JVC Service Bulletin

SUBJECT: TO IMPROVE PICTURE AND SOUND NOISE

DATE: MARCH, 2005

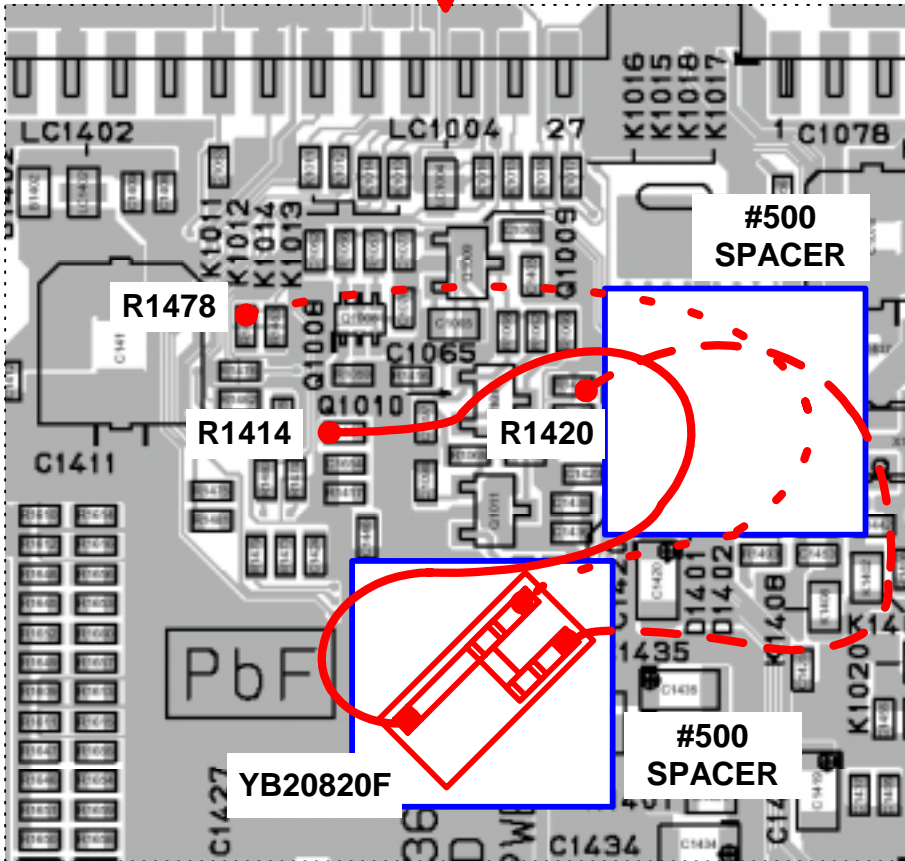
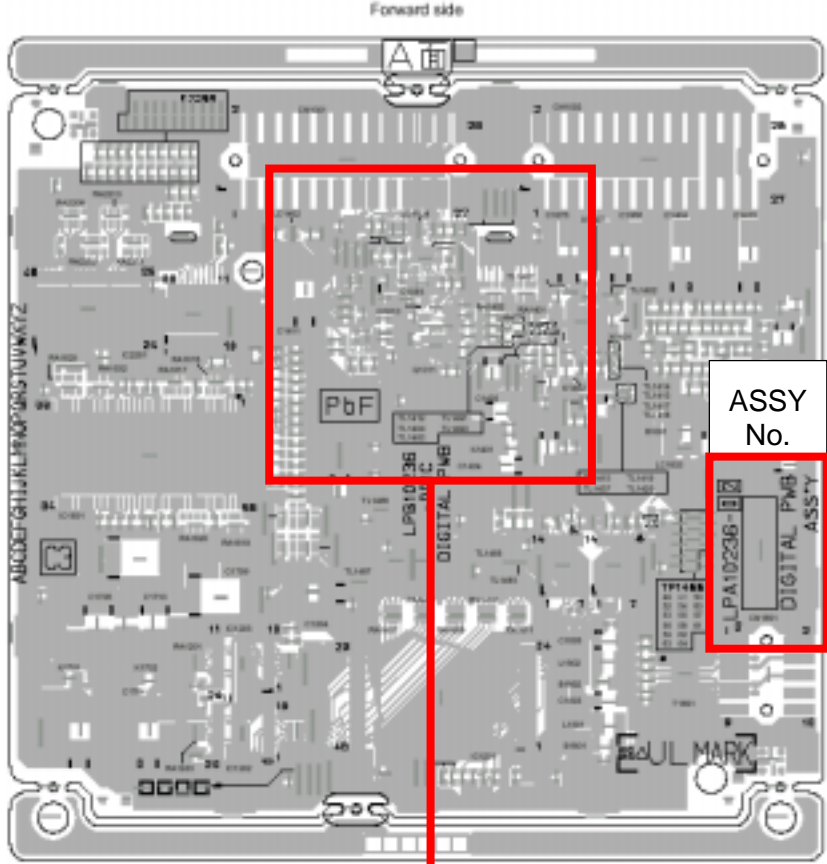
1. Countermeasure for DR-M10, DR-MV1

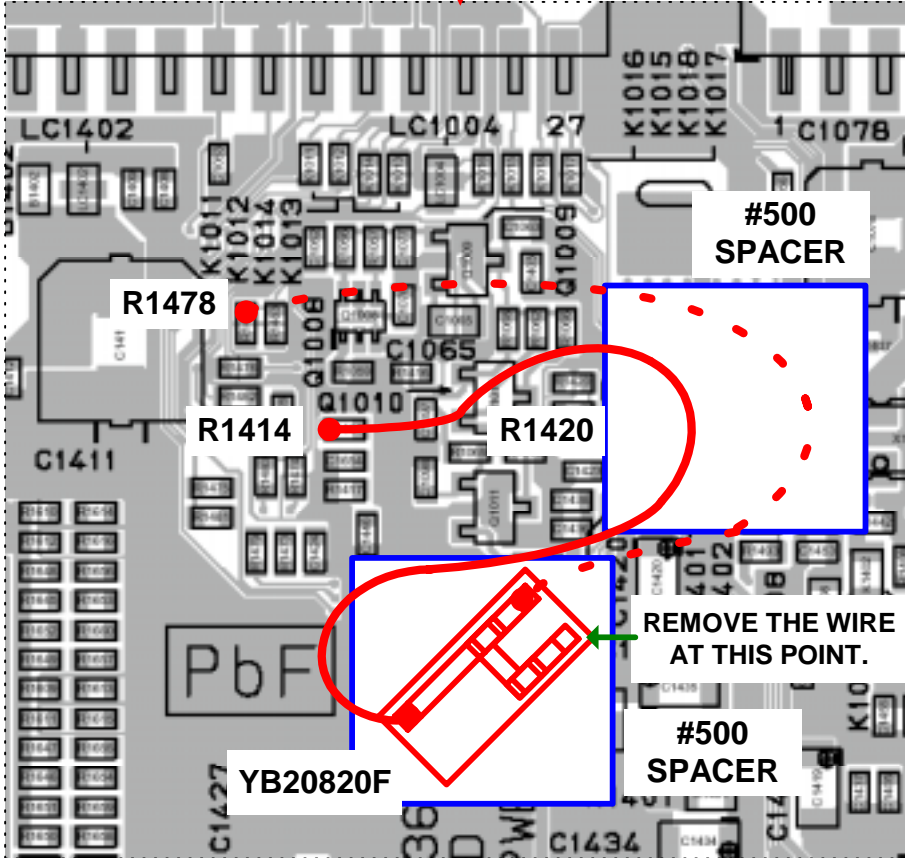
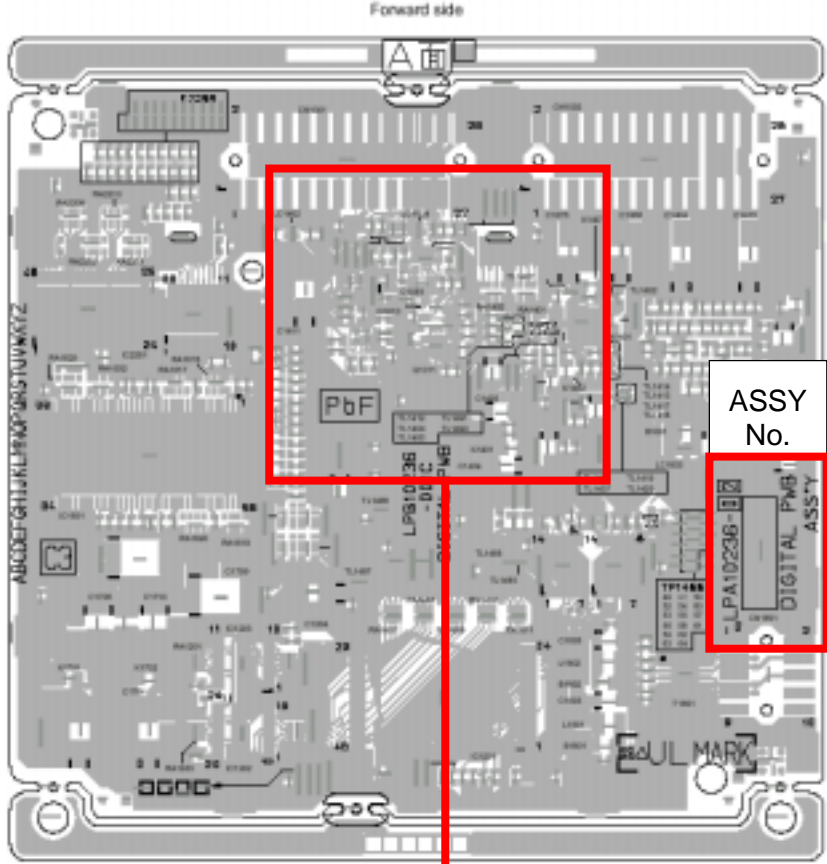
A) Add a SUB PWB ASSY (YB20820F1) on the DIGITAL BOARD ASSY as shown below.
#500SPACER: PU59915-105(100pcs/1sheet)

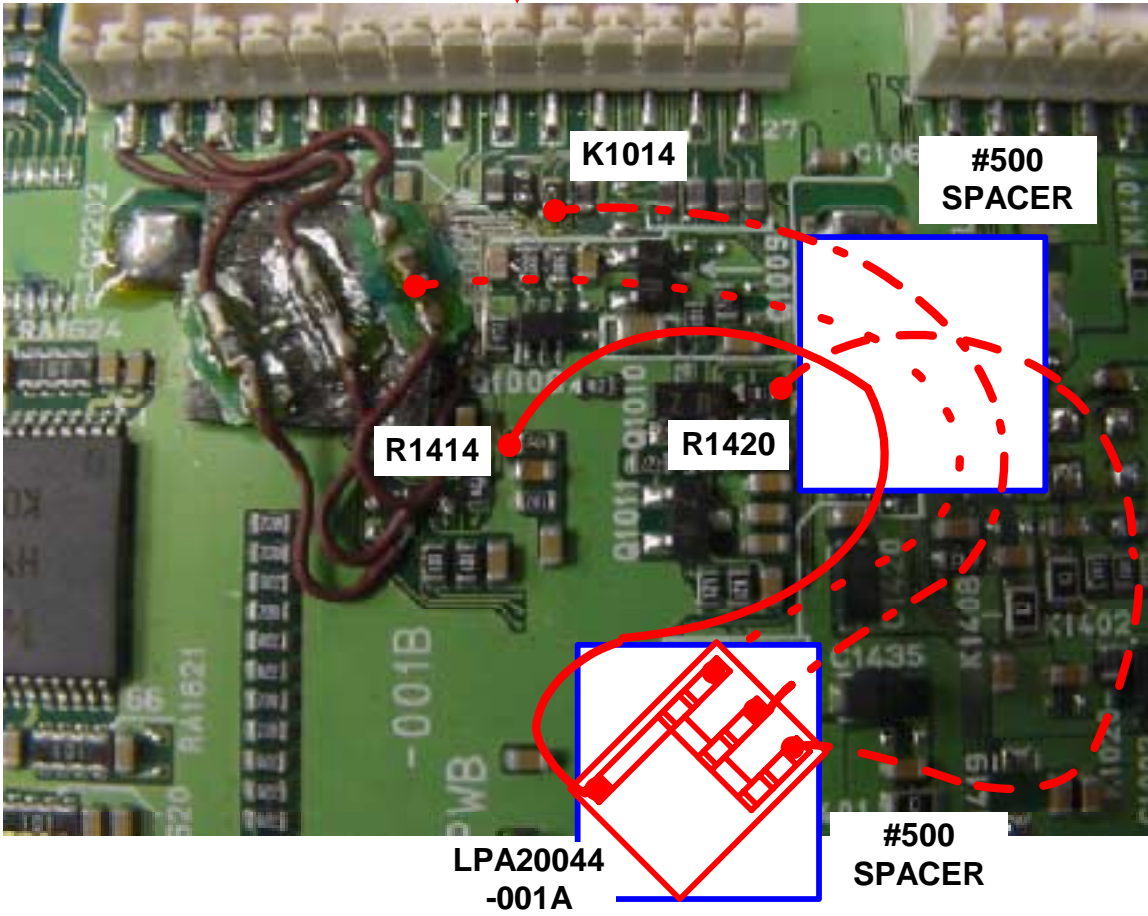
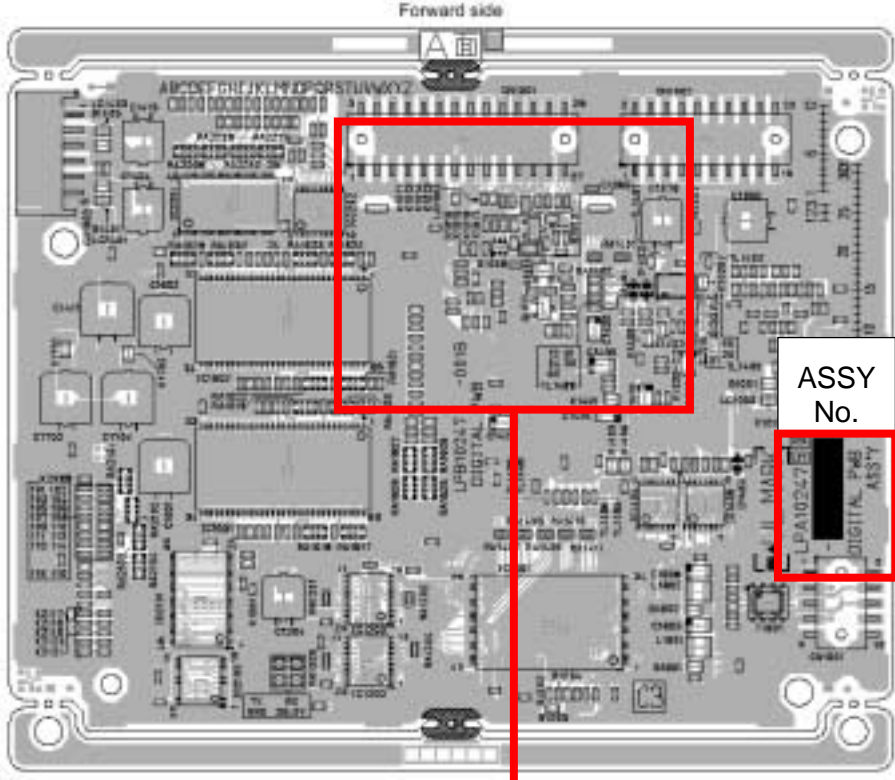
A) Add a SUB PWB ASSY (LPA20044-001A) on the DIGITAL BOARD ASSY as shown below.
#500SPACER: PU59915-105(100pcs/1sheet)

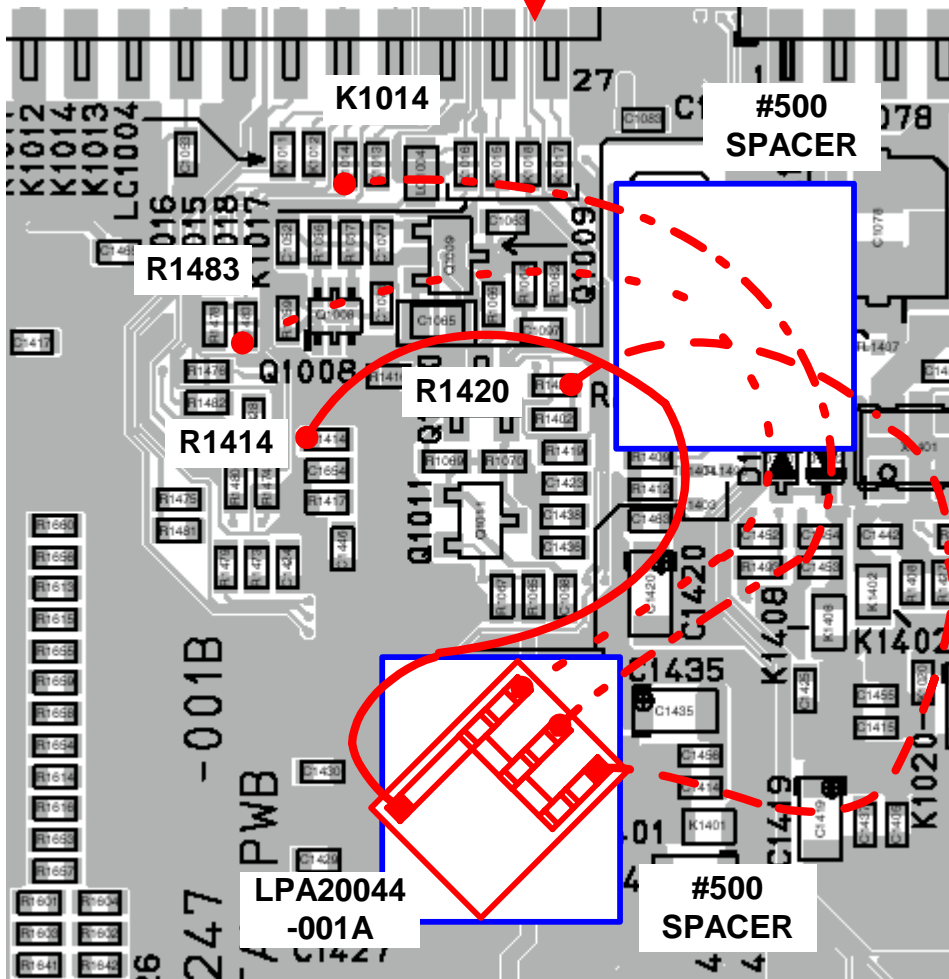
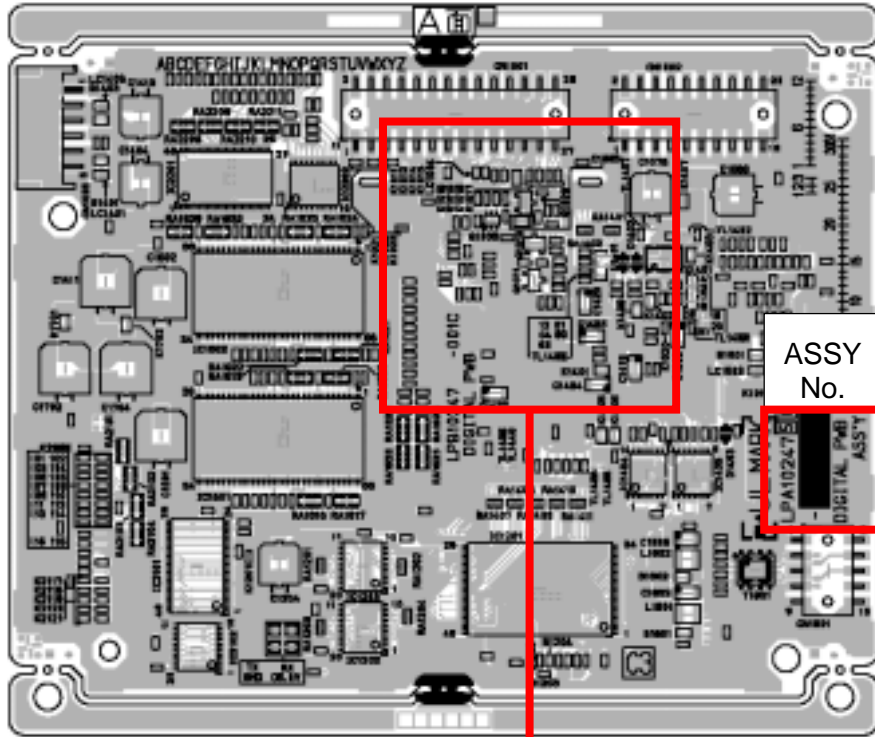
B) Add a SUB PWB ASSY (LPA20044-001A) on the DIGITAL BOARD ASSY as shown below.
#500SPACER: PU59915-105(100pcs/1sheet)
